La Jolla Shores Planned District Advisory Board (LJSPDAB) APPLICANT PROJECT INFORMATION FORM

- Project Tracking System (PTS) Number/Accela "PRJ" Number and Project Name (only submitted projects to the Development Services Department can be heard as action items):
PRJ-1153151 Kaplan Addition

- Address and APN(s):
2255 Paseo Dorado, APN 346-372-0400
- Project contact name, phone, e-mail:
Eric Buchanan 619-204-8248, eric@oasis-ad.com
- Project description:
First and second floor addition to the existing one-story residence with attached 3-car garage. Interior remodel of kitchen, living room, laundry and powder bath.

KAPLAN RESIDENCE

SITE PLAN

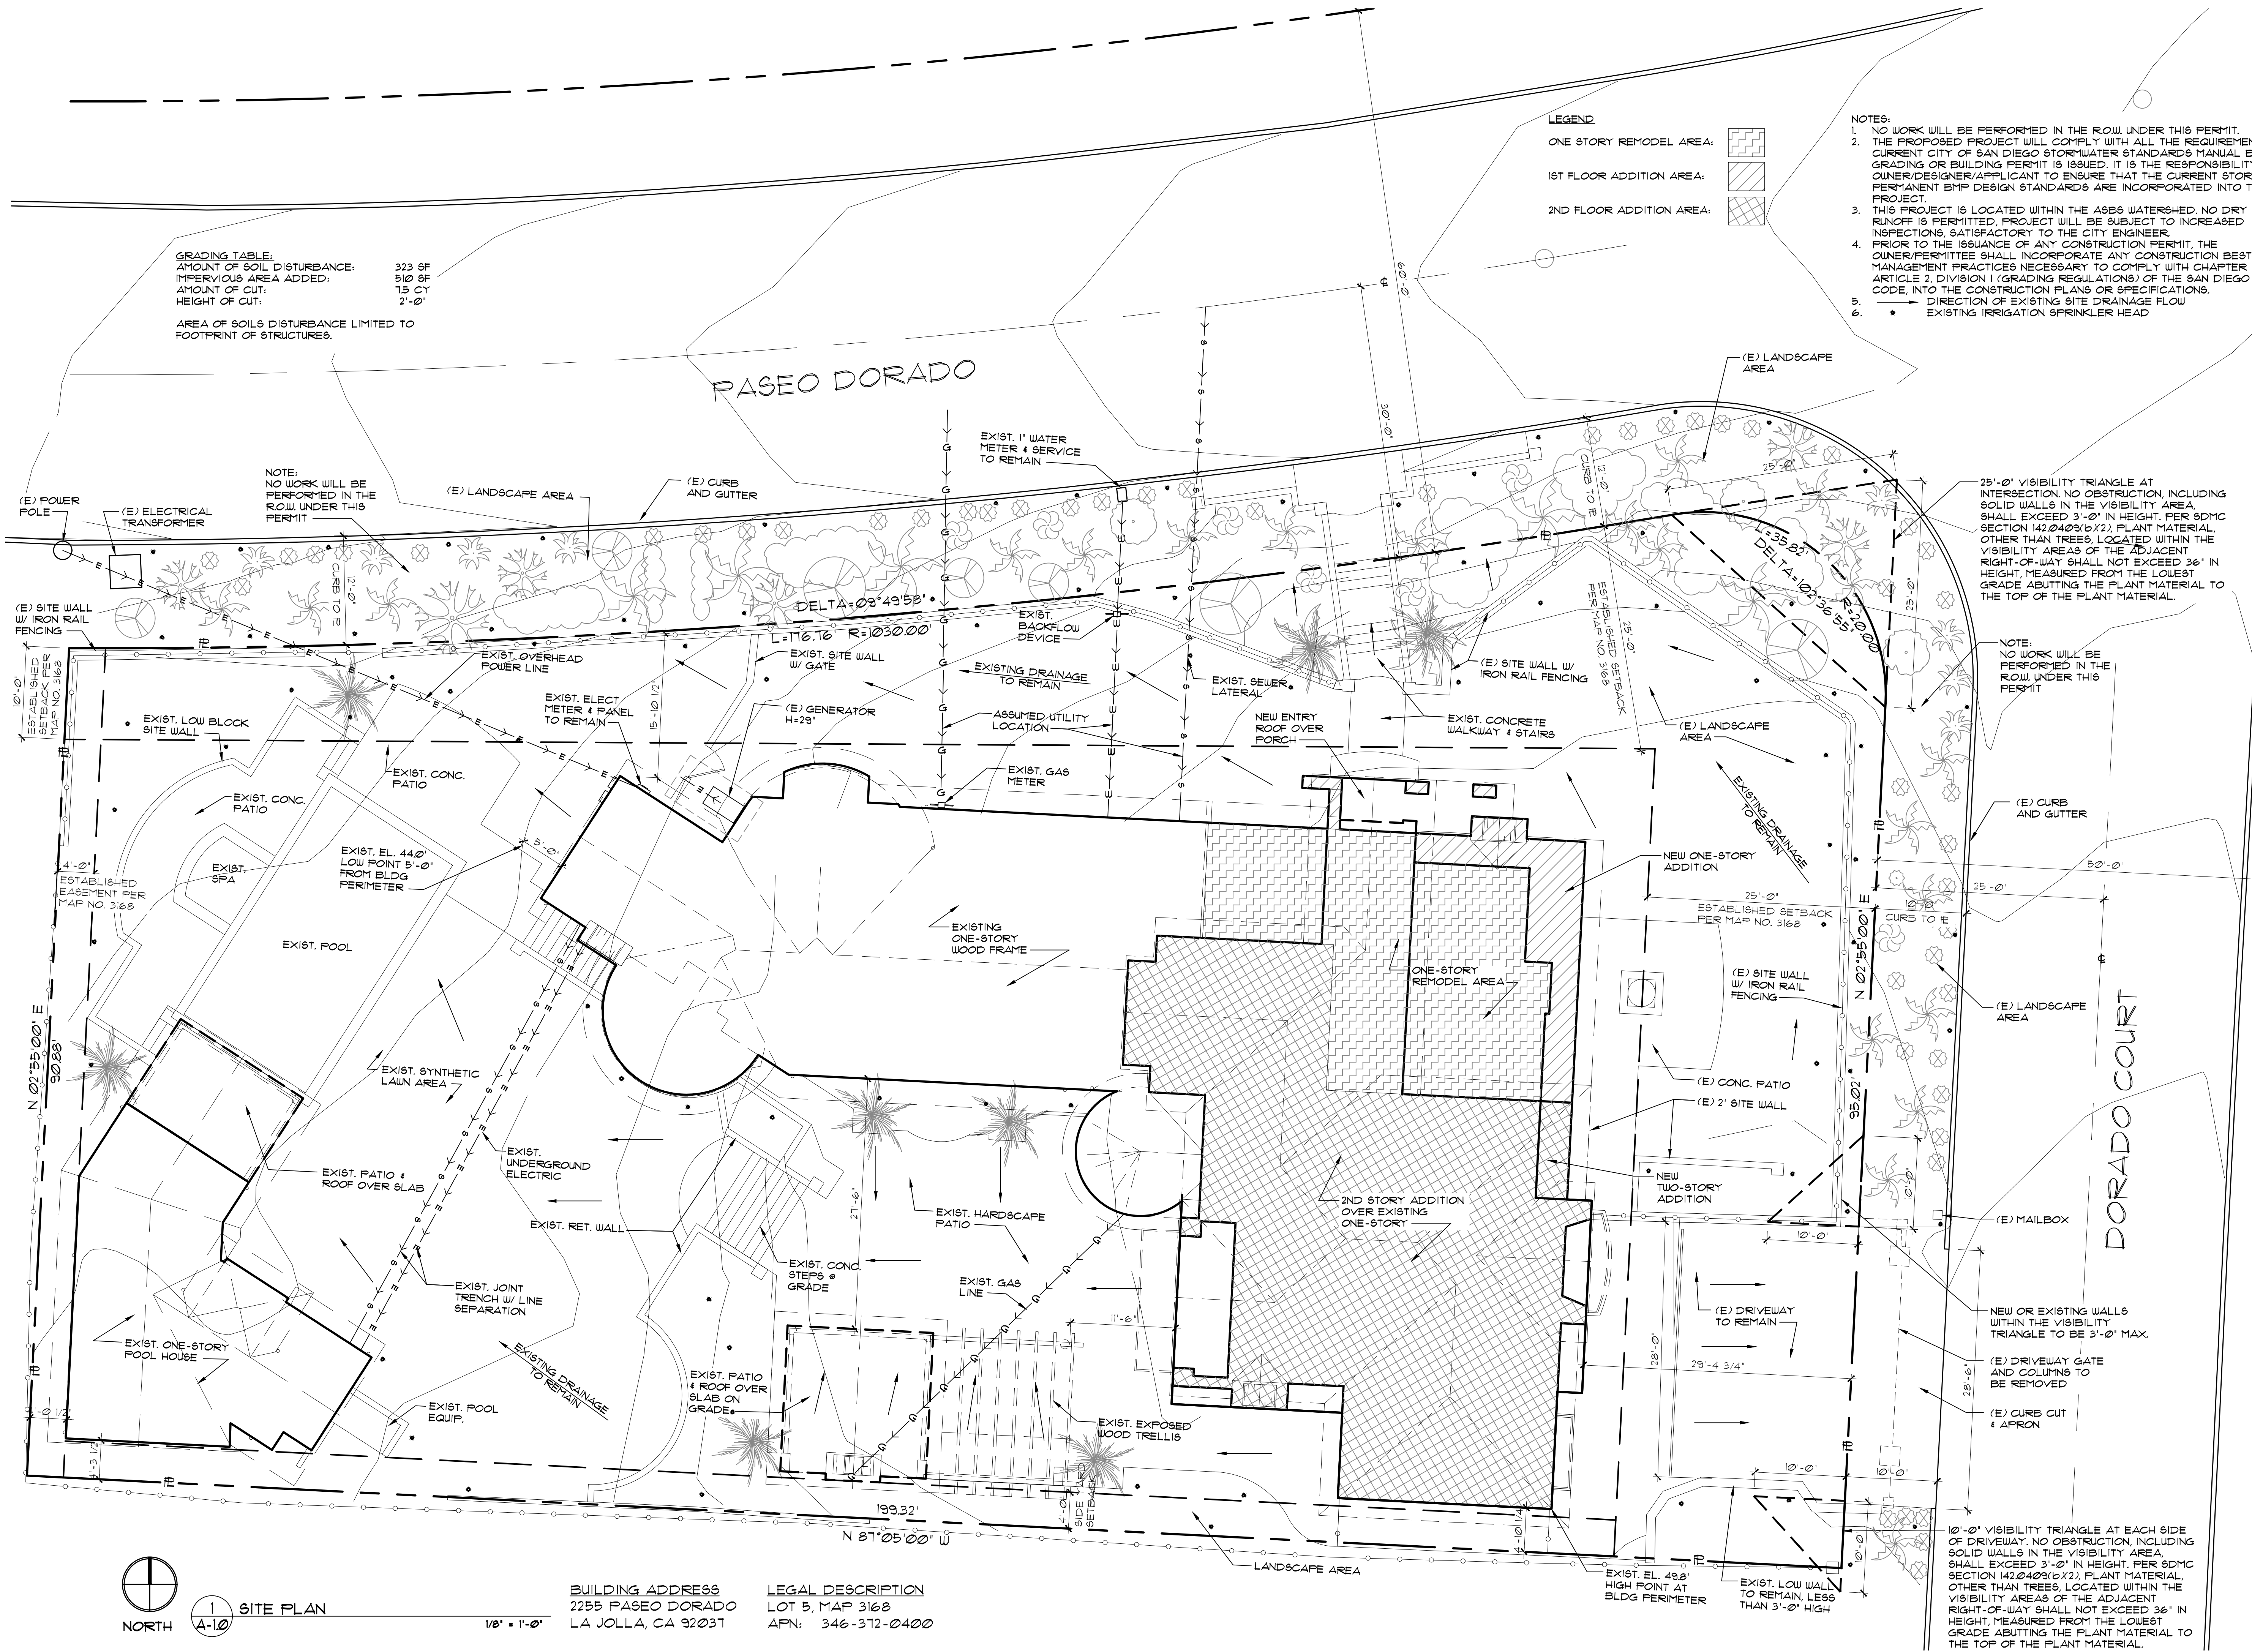
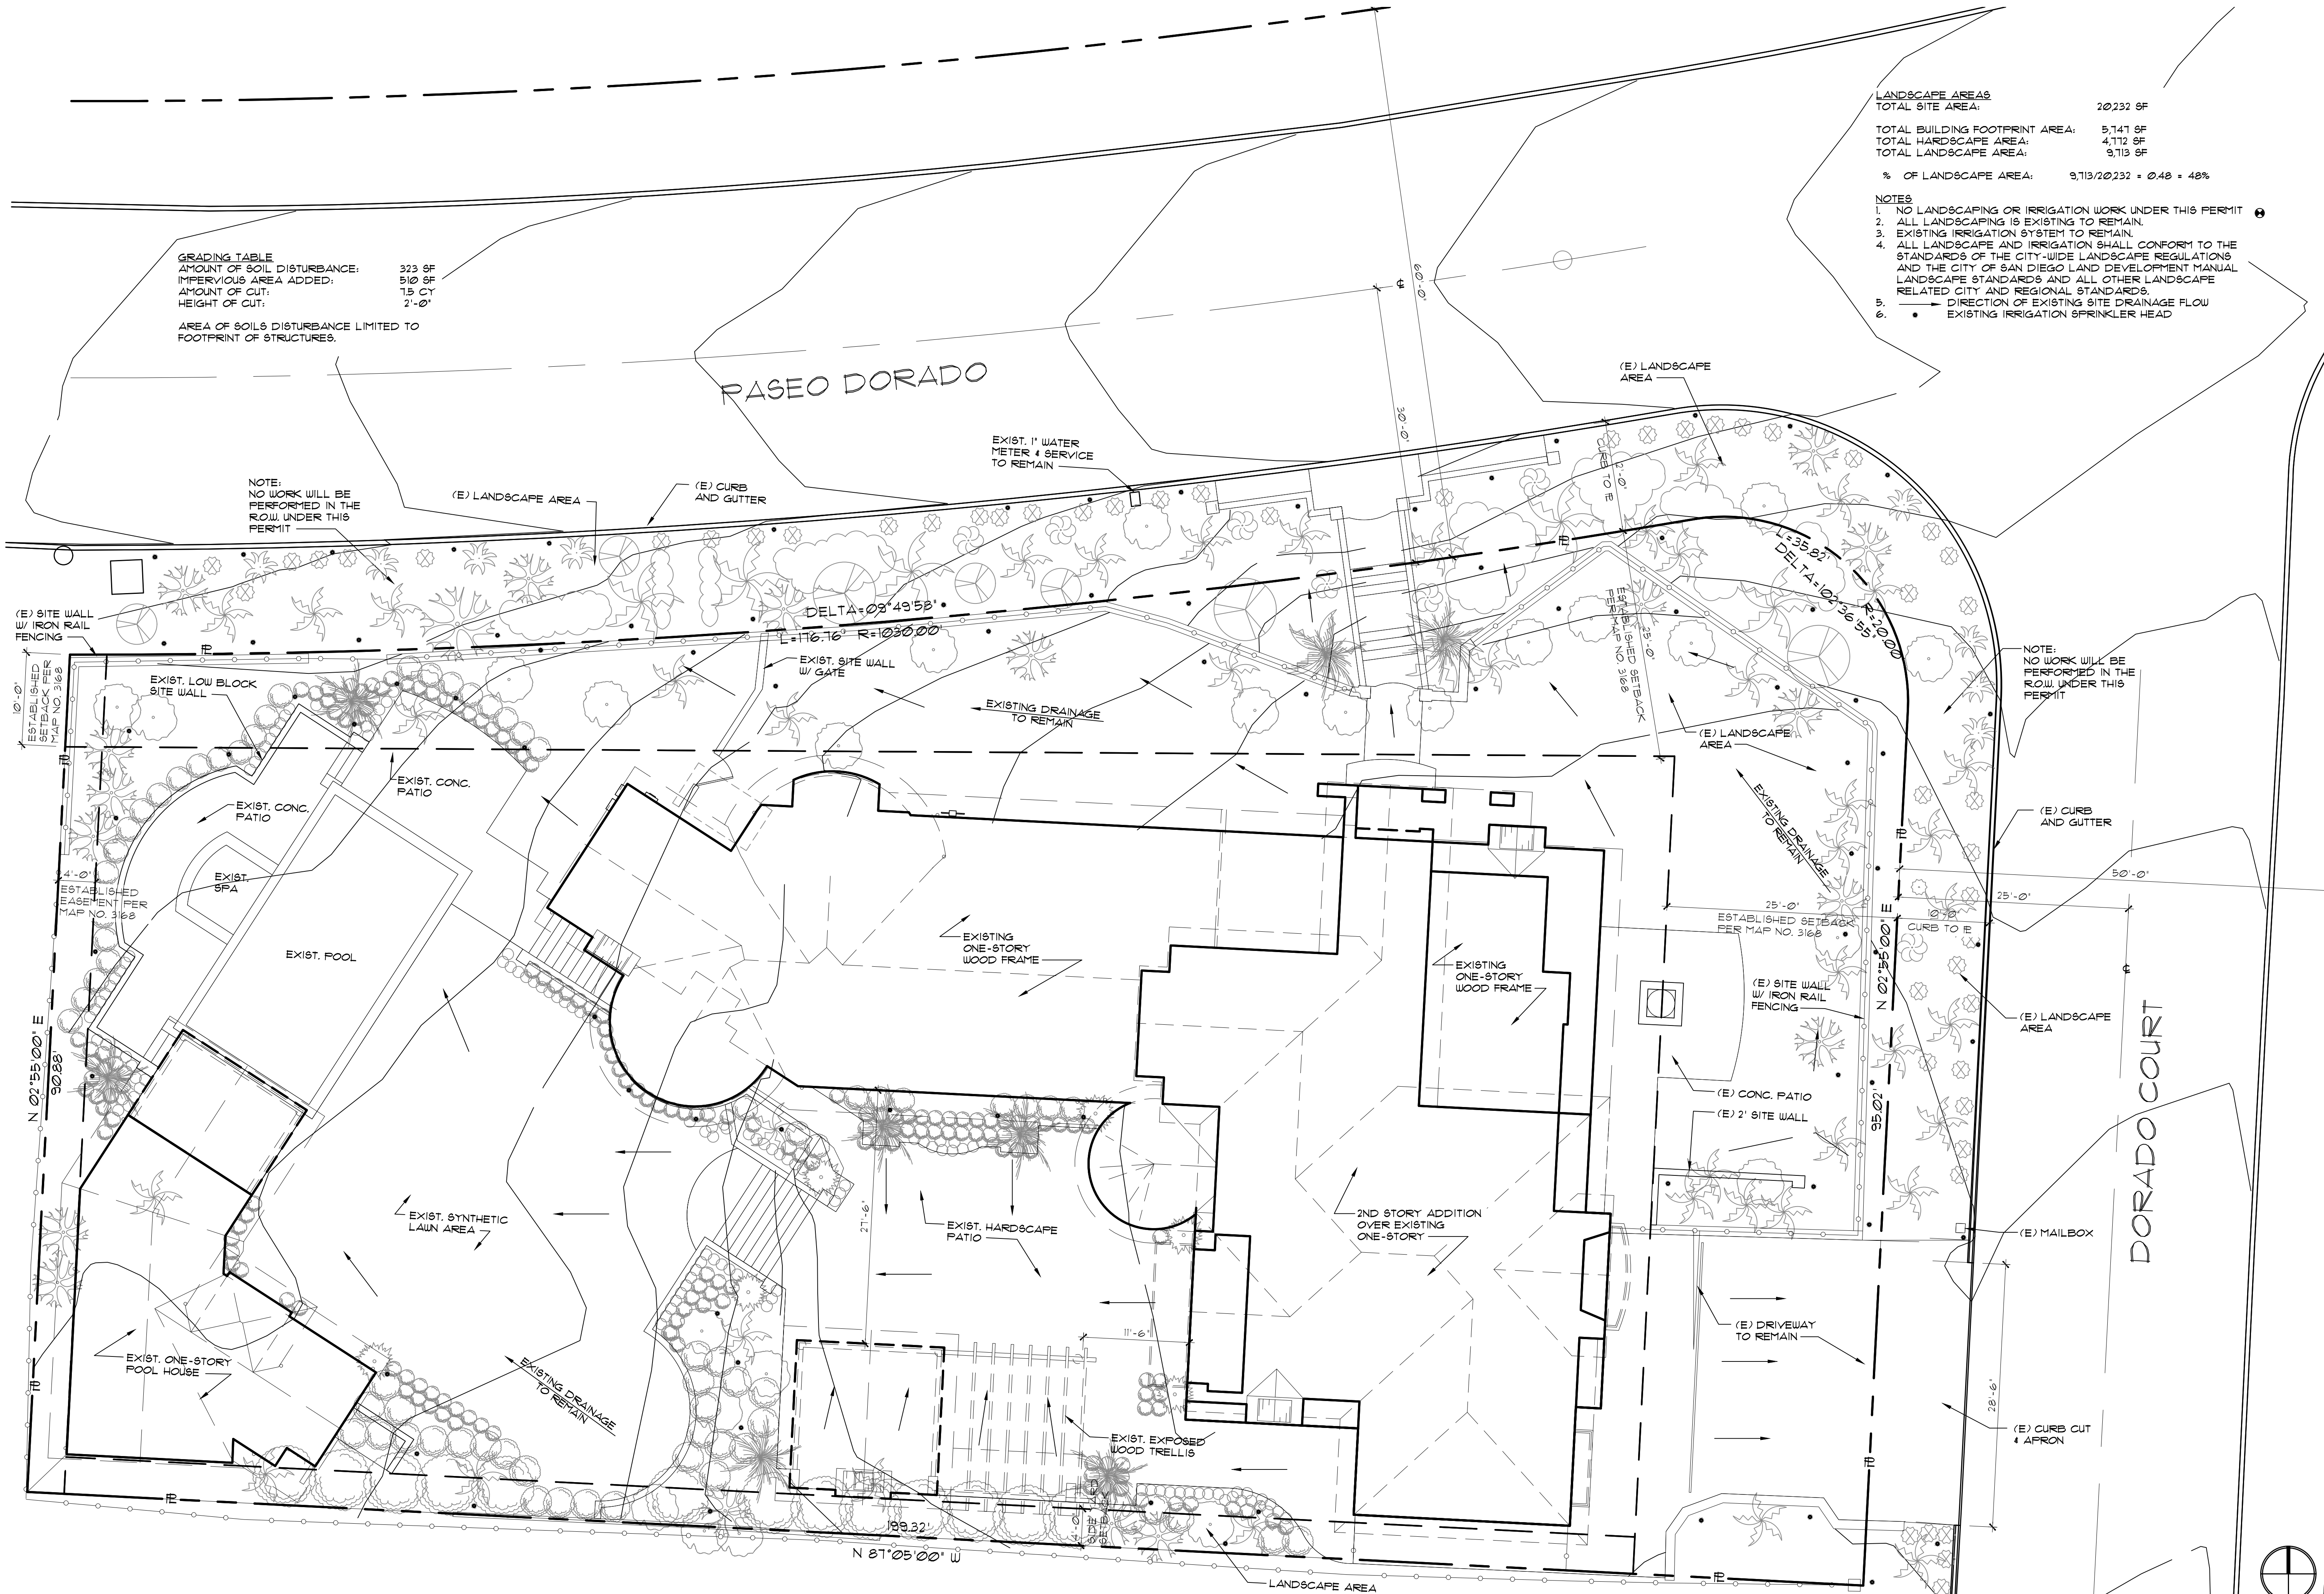
Follow up to comment 20, revise the site plan to relocate the driveway gate out of the public right-of-way to private property.

Follow up to comment 22, revise the site plan to show and call out the reconstruction of the walls within the visibility triangle to 3' or less in height.

On the site plan, please show and label the highest and lowest points. Please see below:

LANDSCAPE AREAS

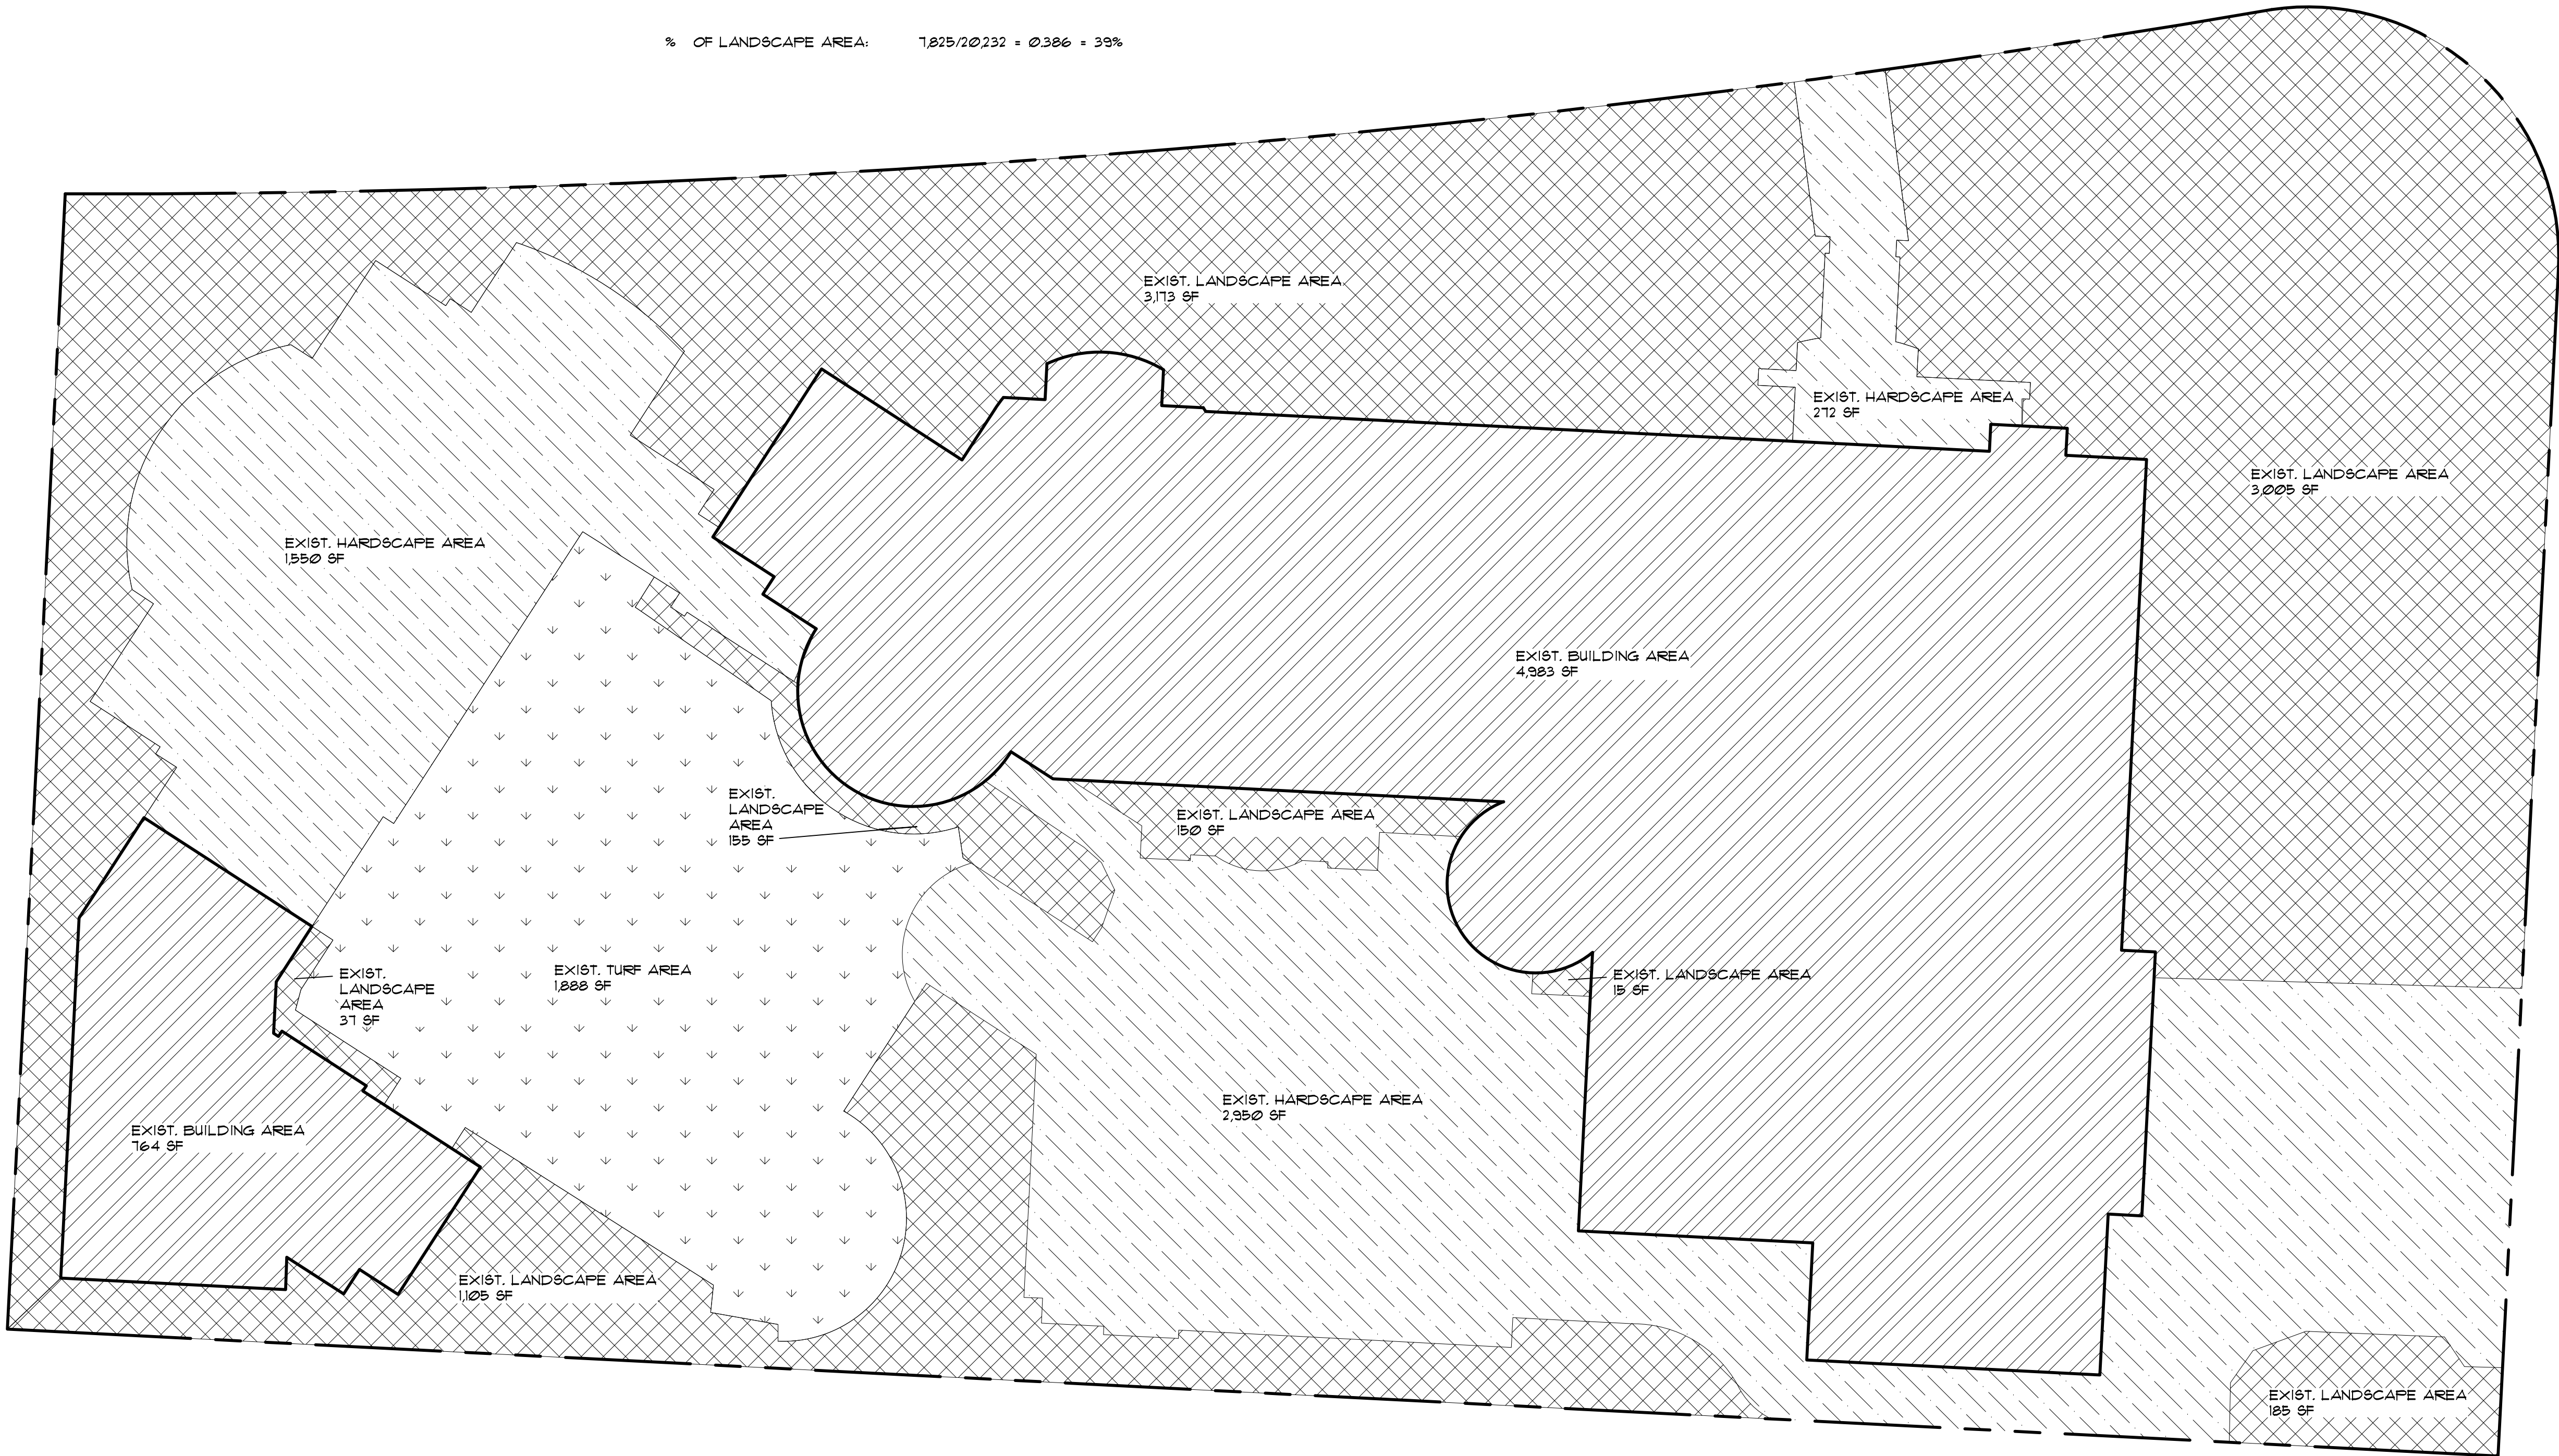
Recheck 7/16/26: Thank you for providing the landscape areas diagram. There are areas on the diagram on sheet A-1.3 that are shown on sheet A-1.2 as either hardscape or synthetic grass. Only vegetated and planted areas count toward landscaped areas. Please update the diagram to exclude non-vegetated areas.

Recheck 7/16/26: Landscape Area Calculations: Once the diagram has been updated, please update the landscape area calculations on sheet A-1.3.
